SUNDRY	NOTICES AND REPOR	TS ON WELLS AL	IG 06 2018 NMN	Serial No. M13838	
abandoned we	is form for proposals to c II. Use form 3160-3 (APD) for such proposals	6. If Indi	an, Allottee or Tribe Name	
SUBMIT IN	TRIPLICATE - Other instr	uctions on page 2		t or CA/Agreement, Name and/or 1 91

1. Type of Well Oil Well 🛛 Gas Well 🗖 Ot		8. Well Name and No. ADOBE FEDERAL COM 01			
2. Name of Operator MARATHON OIL PERMIAN I		9. API Well No. 30-025-26887-00-S1			
3a. Address 5555 SAN FELIPE STREET HOUSTON, TX 77056		10. Field and Pool or Exploratory Area ANTELOPE RIDGE-BONE SPRIM

P& A PROCEUDRE for ADOBE FED #1

Permanent Abandonment of Federal Wells Conditions of Approval

Prior to PAA

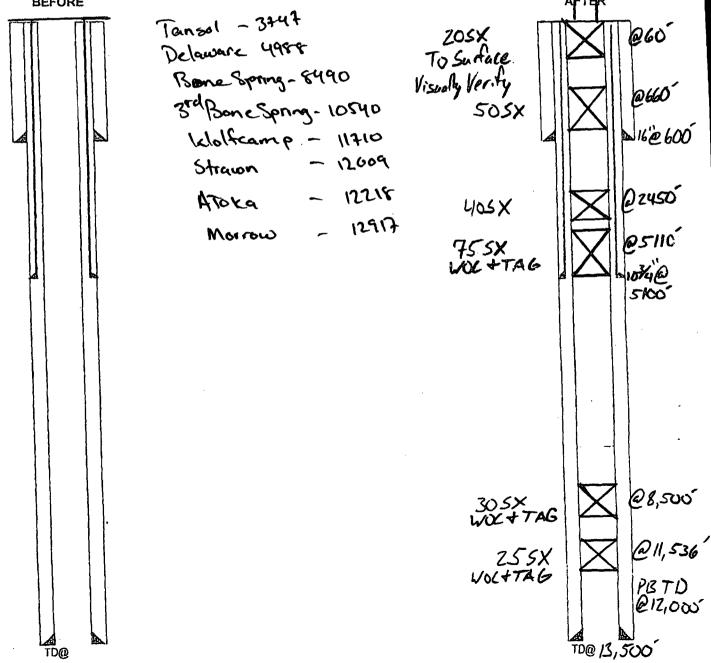
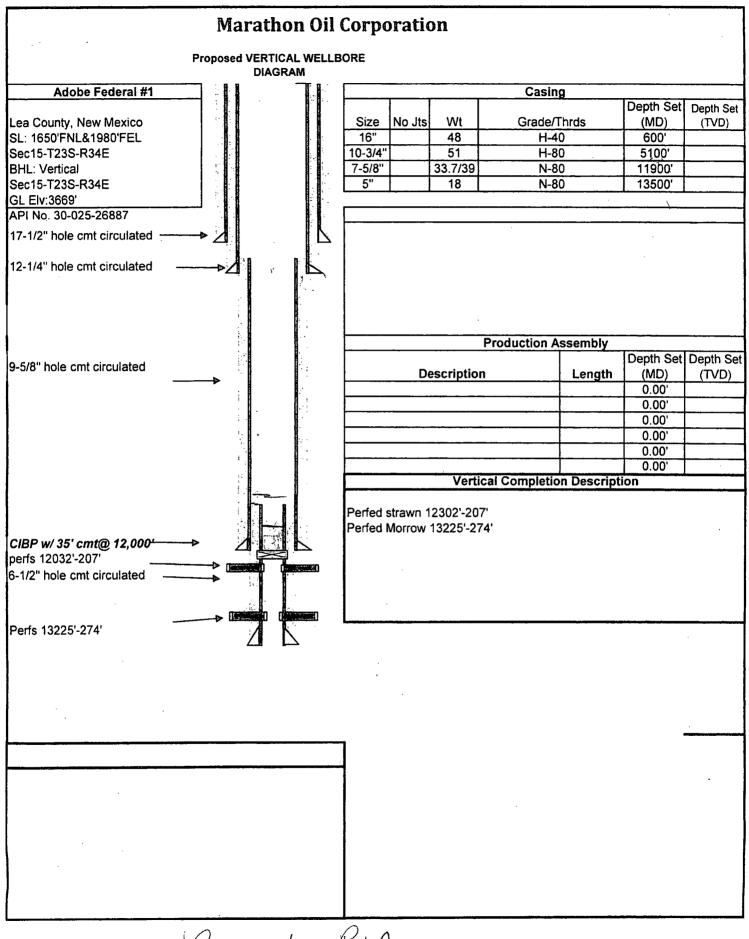
If the proposal is to deepen direction Attach the Bond under which the wo following completion of the involve testing has been completed. Final A determined that the site is ready for 1) 25sx @ 11,536' - 11,436' ta 2) 30sx @ 8500' - 8400' tag. 3) 75sx @ 5110' - 4771' tag. 4) 40sx @ 2450' - 2350' 5) 50sx @ 660' - 560' 6) 20sx @ 60' - surf. Verify Install DHM P&A mud between all plugs.	ally or recomplete horizontally, g ork will be performed or provide i d operations. If the operation resi- bandonment Notices must be file final inspection. ag.	give subsurface locations and measurface locations and measurface Bond No. on file with BLM/BI/ ults in a multiple completion or rec d only after all requirements, inclu-	ared and true vertical depth A. Required subsequent re completion in a new interva ding reclamation, have bee d Office bbs cree ATT	ns of all pertinent markers and zone ports must be filed within 30 days I, a Form 3160-4 must be filed one in completed and the operator has
